**Re: NMCC Expansion  
4901 Lang Ave. NE  
Conceptual Traffic Circulation Layout for DRB Approval  
Engineer's Stamp 08-24-22 (D17-D003V1)**

**Reference: NMCC Expansion – 4901 Lang Ave. NE Traffic Circulation Layout (DIV-D003V1)  
Comment Response Letter, 4th Submittal**

TRAFFIC CIRCULATION LAYOUT  
NMCC EXPANSION  
4901 LANG AVE. NE

DETAILS

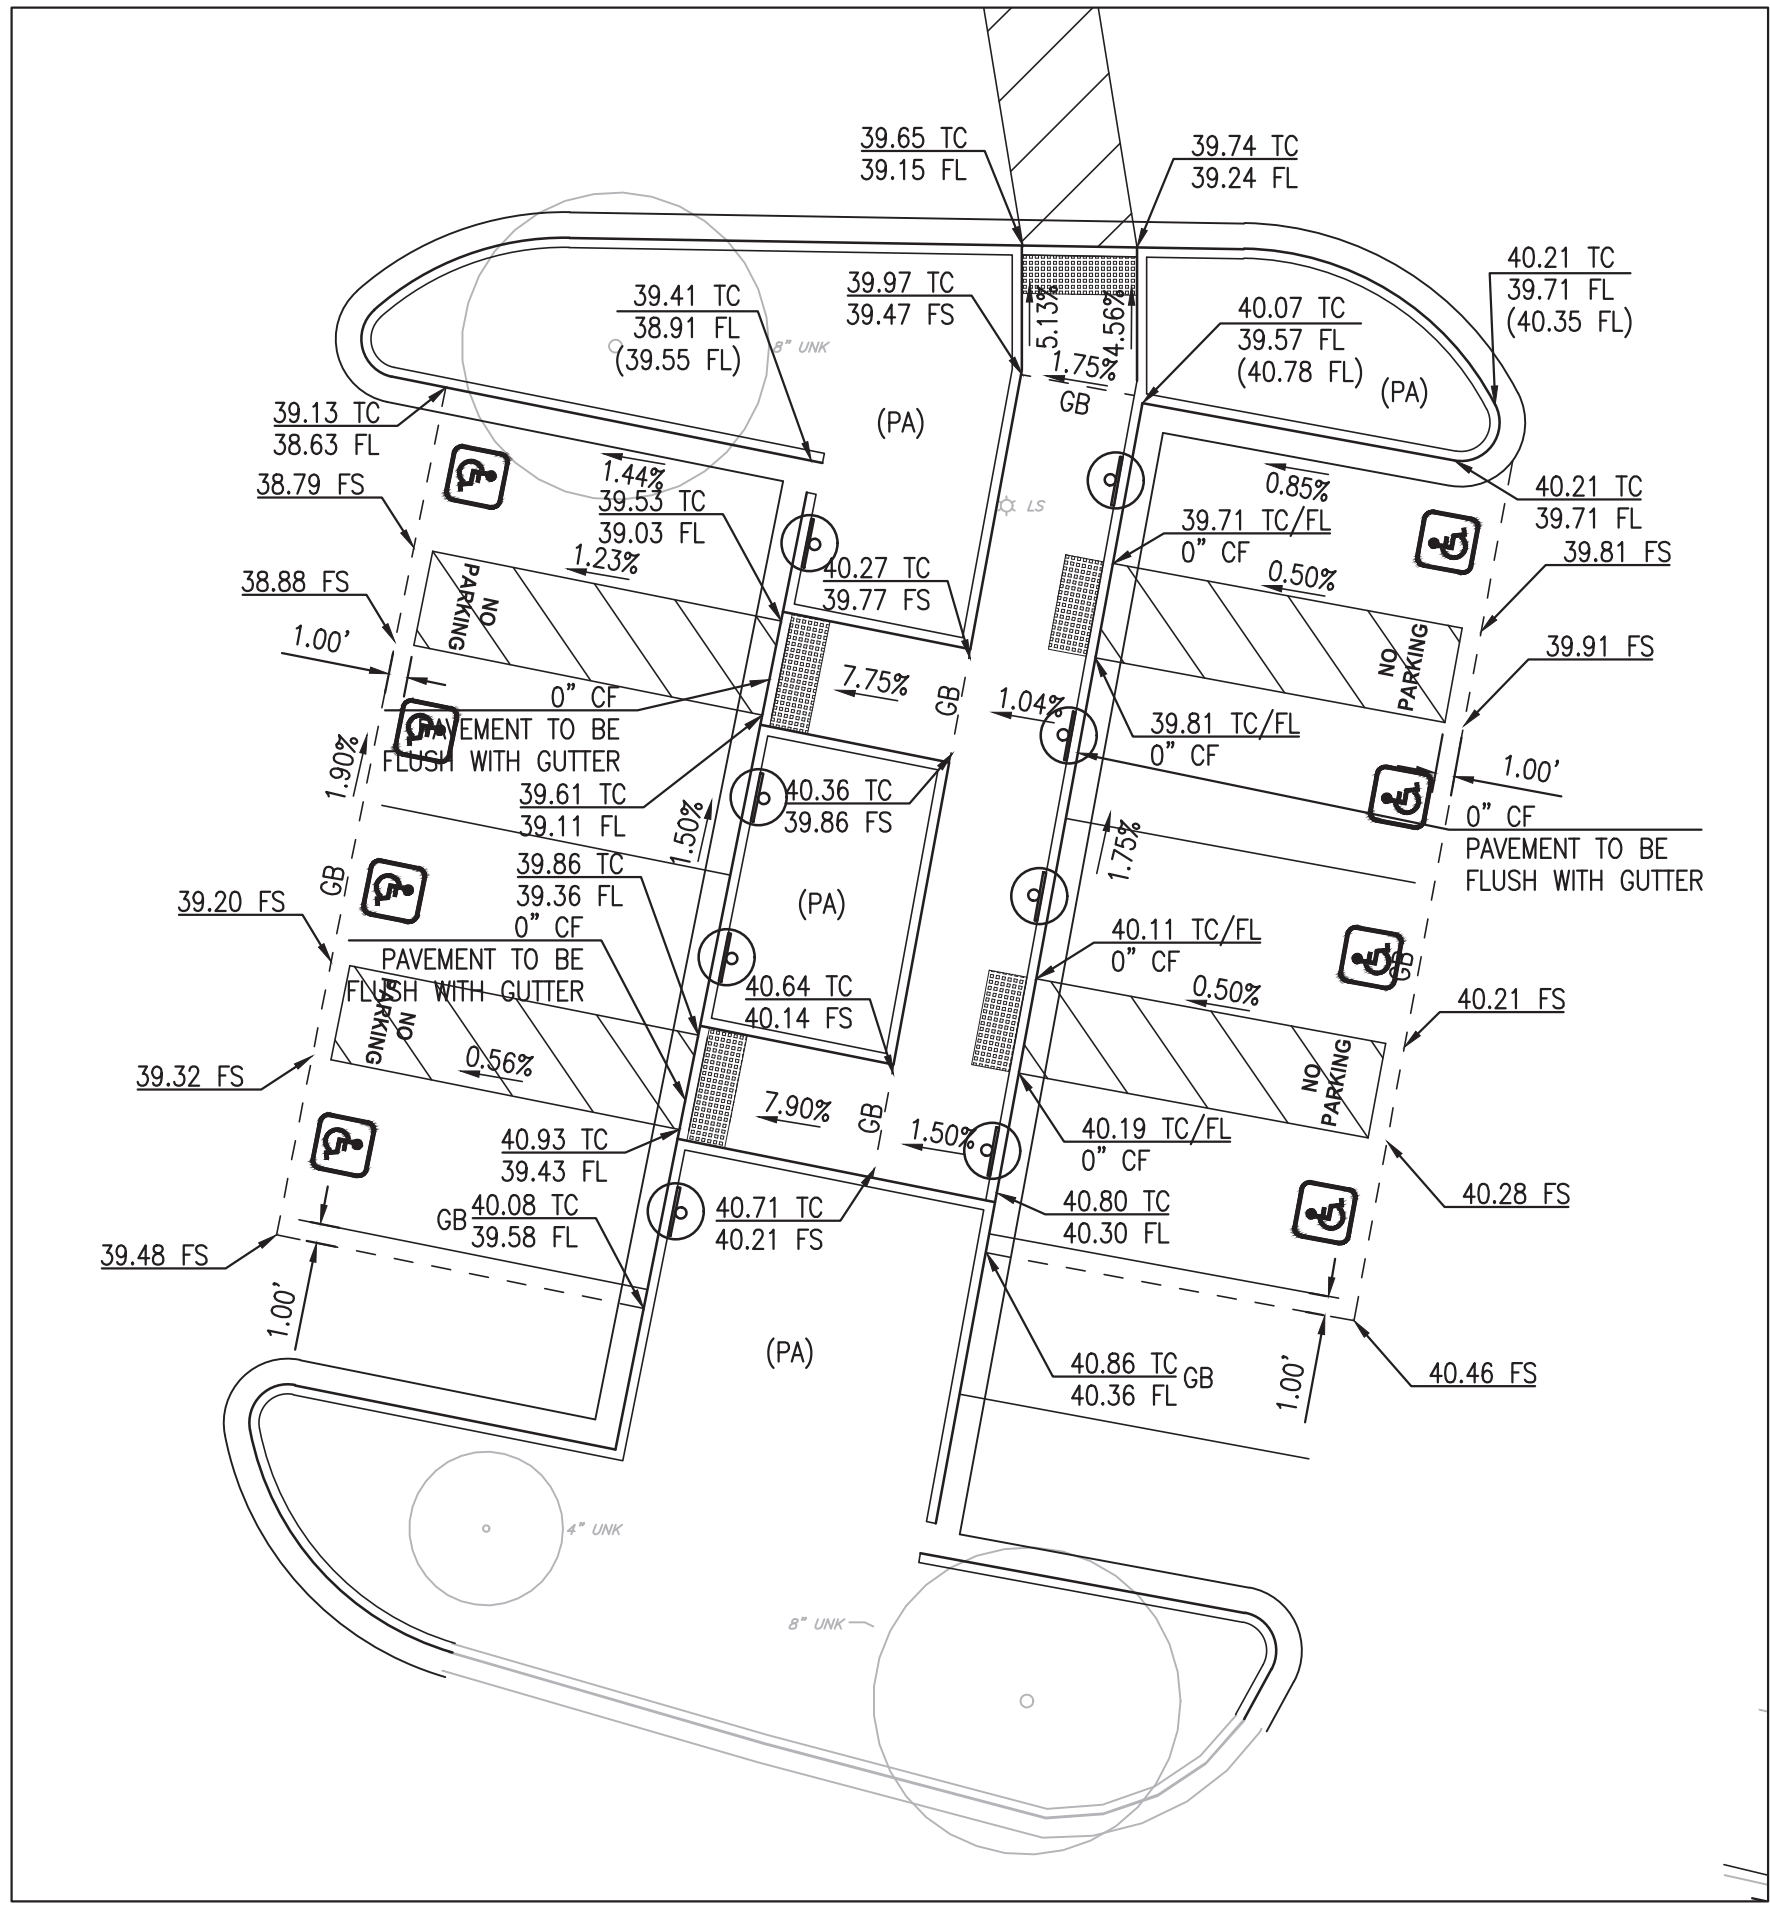
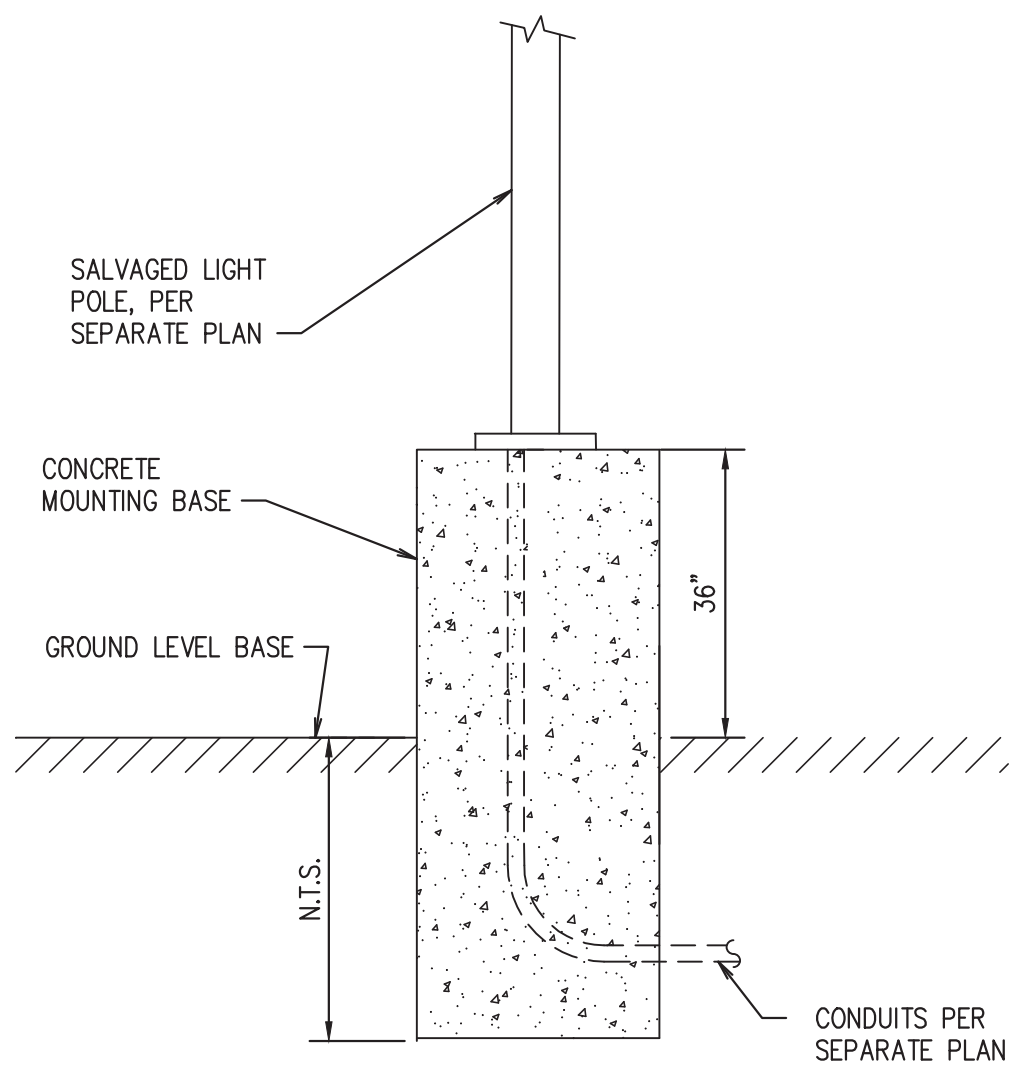
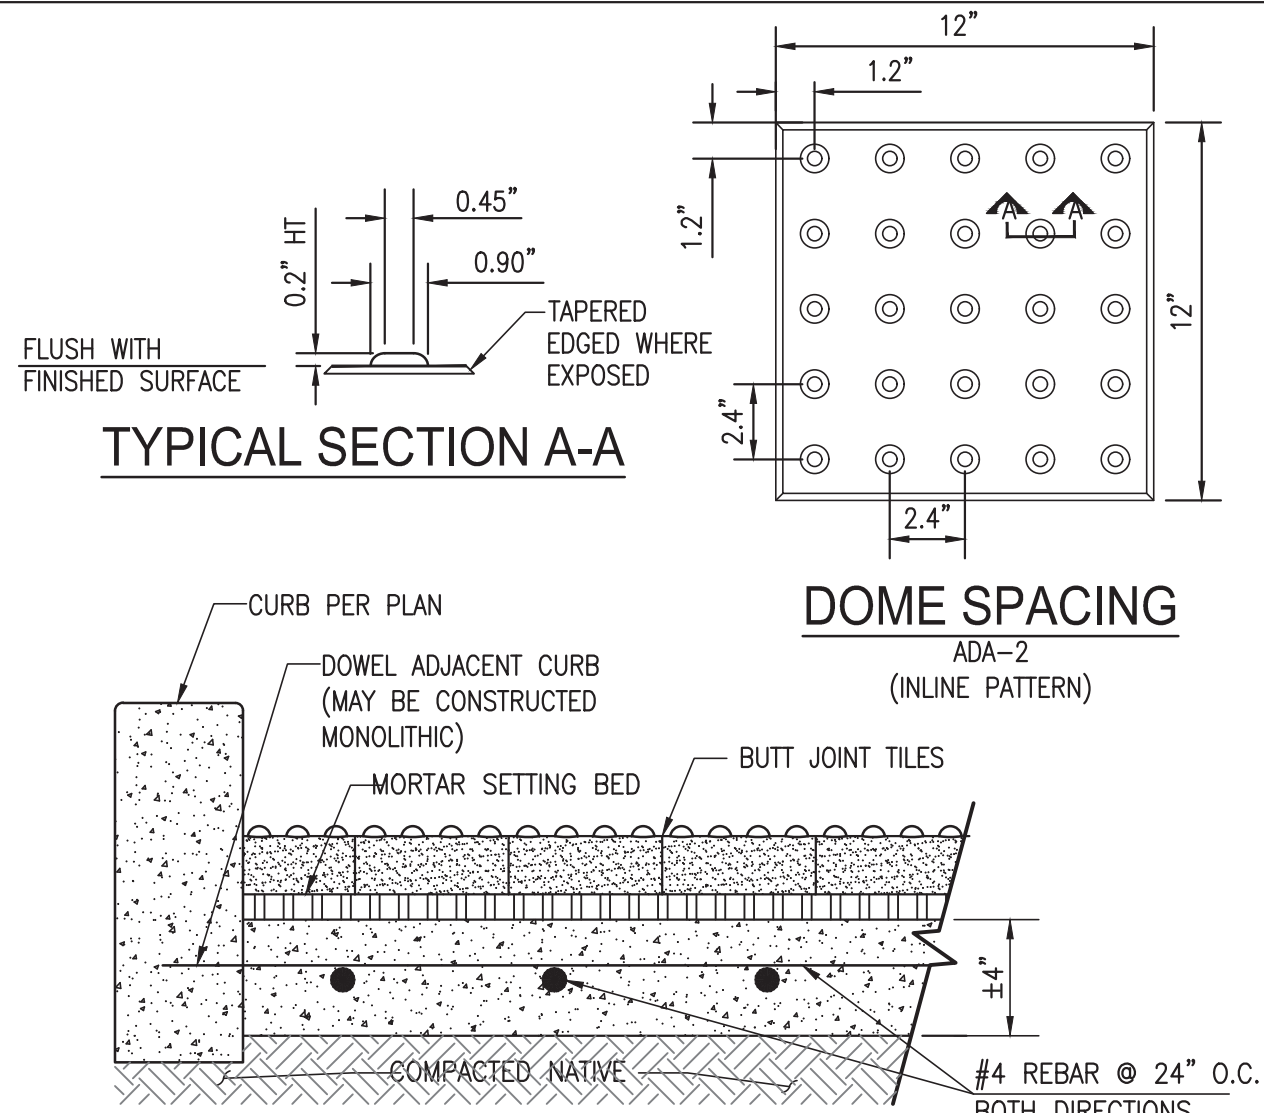
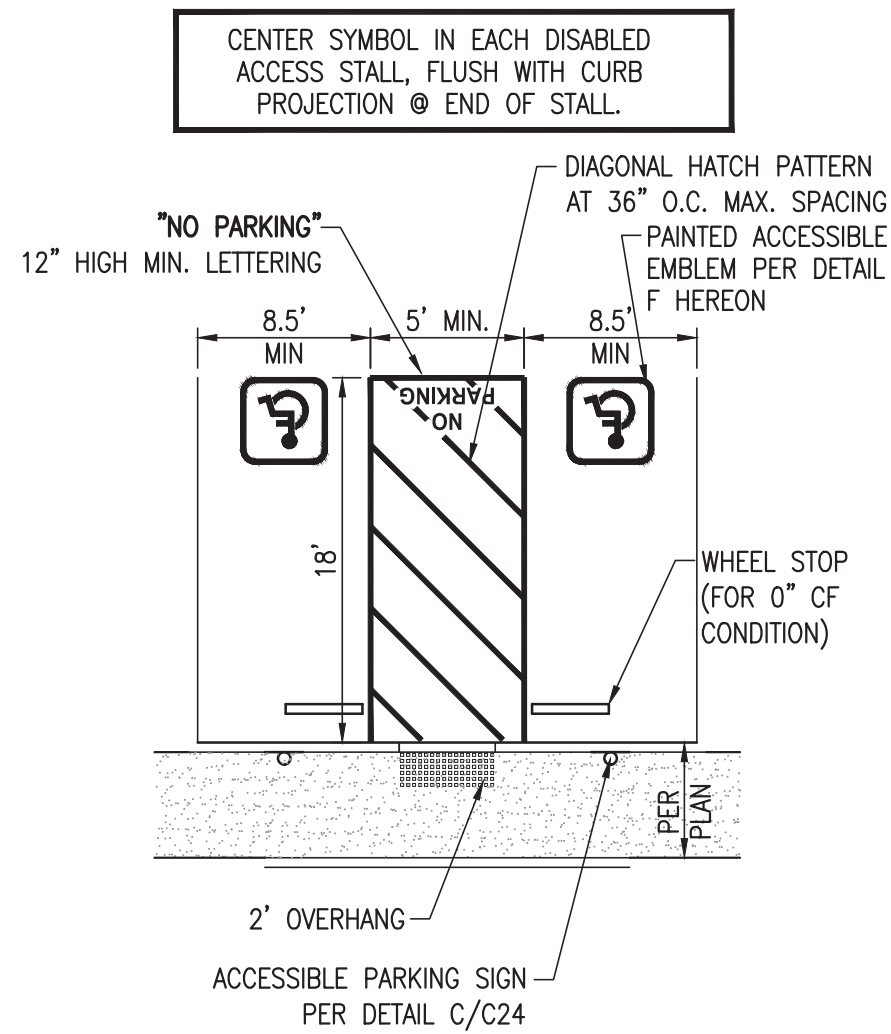
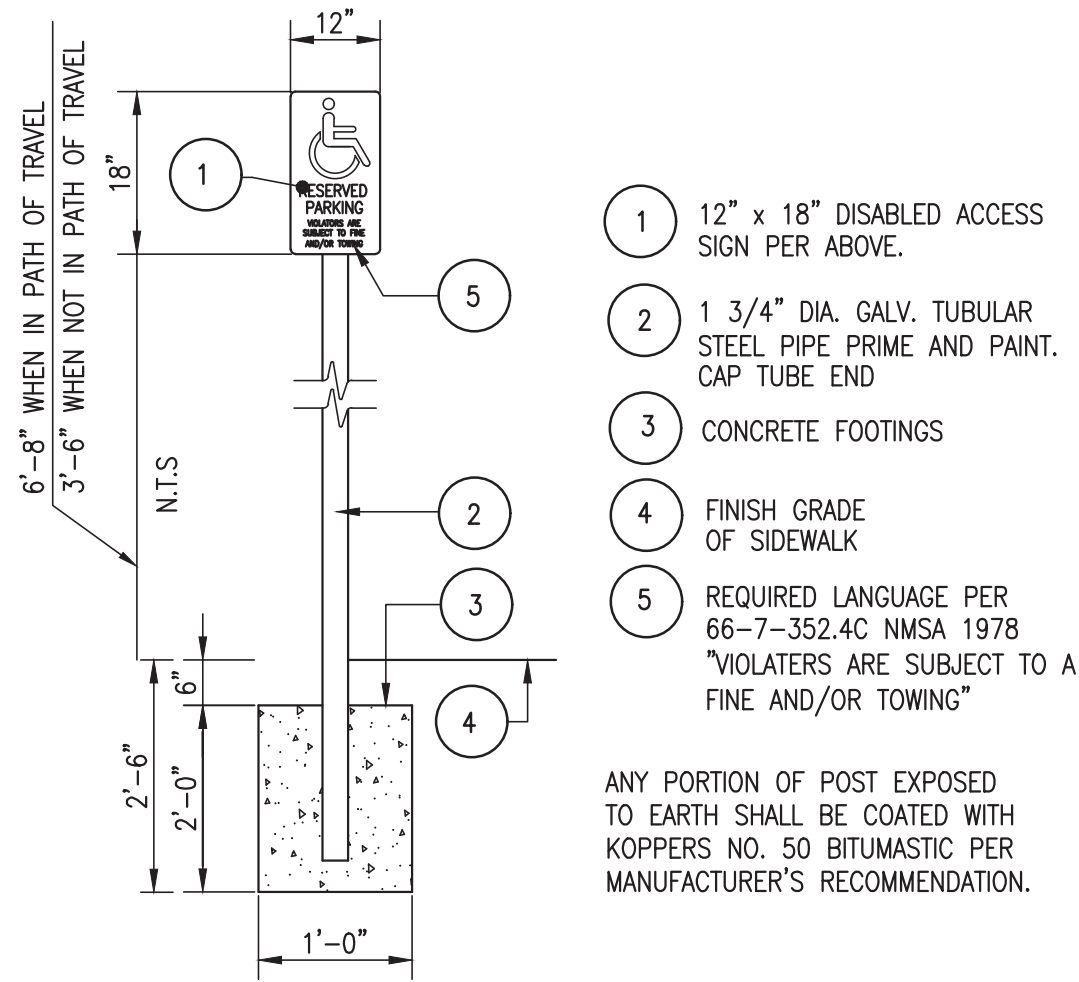
2. Please define ADA pathways by labeling ramps, flush pavement, and provide all proposed ramps details. Call out ramps with a keynote on the site plan too.

*Response: Notes have been added to both the exhibit and site plan. Ramp are provided on sheet C-501.*

## SITE PLAN

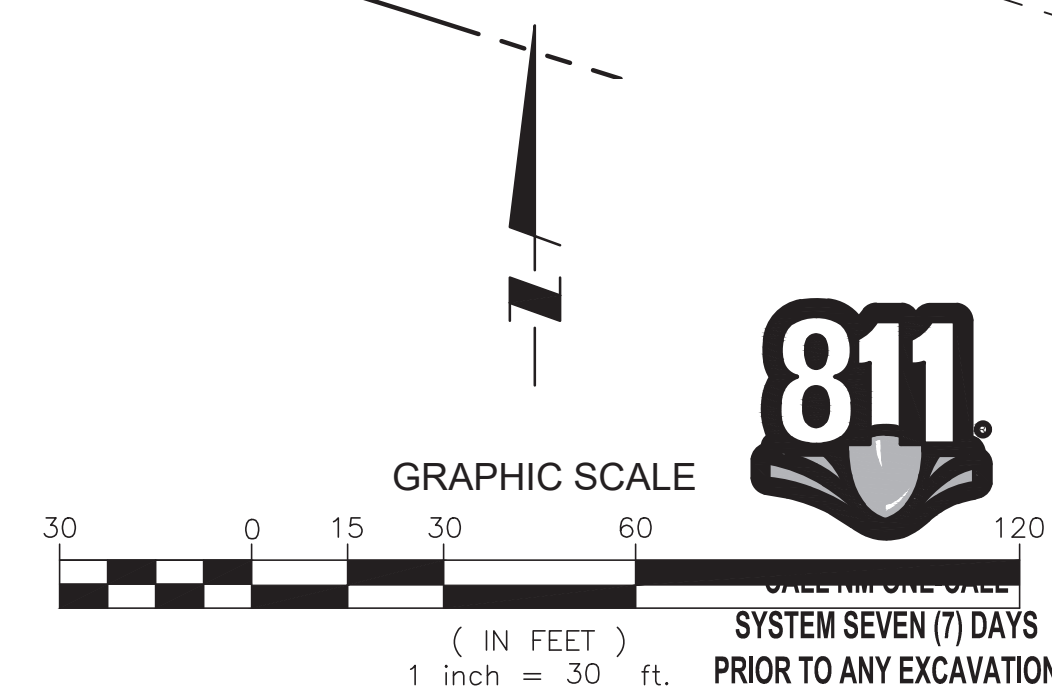
1. Please indicate how many parking spaces will be on the site after new expansion construction.

*Response: Please refer to the parking tabulation near the bottom right corner of the C-101 sheet. Provided motorcycle and van accessible parking stalls were added.*
